Project	IEEE 802.16 Broadband Wireless Access Working Group < http://ieee802.org/16 >	
Title	Primitives for configuration management	
Date Submitted	2005-09-13	
Source(s)	ZTE Corporation	Ou.Zhiqiu@zte.com.cn
	Ou Zhiqiu	Xu.ling@zte.com.cn
	Lei Dali	jqian@ztesandiego.com
	Ling Xu	
	Jeff Qian	
	Zhou Qun	
	Ernie Tacsik,	
	Mary Chion	
	Xiaolu Dong	
	CATR	
	G Q Wang	
	Nortel Networks	
Re:	Contribution on comments to IEEE 802.16 g-05/008	
Abstract	This contribution describes the version configuration management procedure and service primitives that could be exchanged between the BS and the NCMS entities.	
Purpose	Adoption	
Notice	This document has been prepared to assist IEEE 802.16. It is offered as a basis for discussion and is not binding on the contributing individual(s) or organization(s). The material in this document is subject to change in form and content after further study. The contributor(s) reserve(s) the right to add, amend or withdraw material contained herein.

Primitives for configuration management

Figure 305 Procedure of configuration management initiated by NCMS

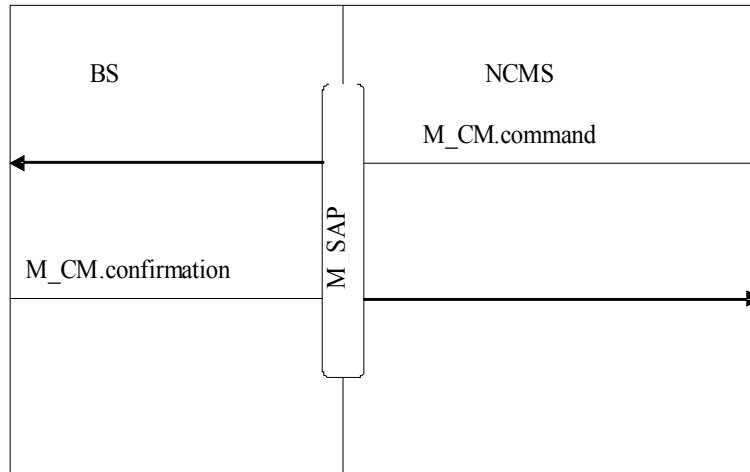
[Insert section 14.5.2 as follow]

When NCMS needs to carry out configuration management, it can initiate the procedure with `M_CM.command` primitive with the specific action type and action information. When BS receives the primitive, it shall act according to the information contained in `M_CM.command` and response with `M_CM.confirmation`. The BS also may generate the `M_CM.notification` primitive to report the status of the configuration information to NCMS.
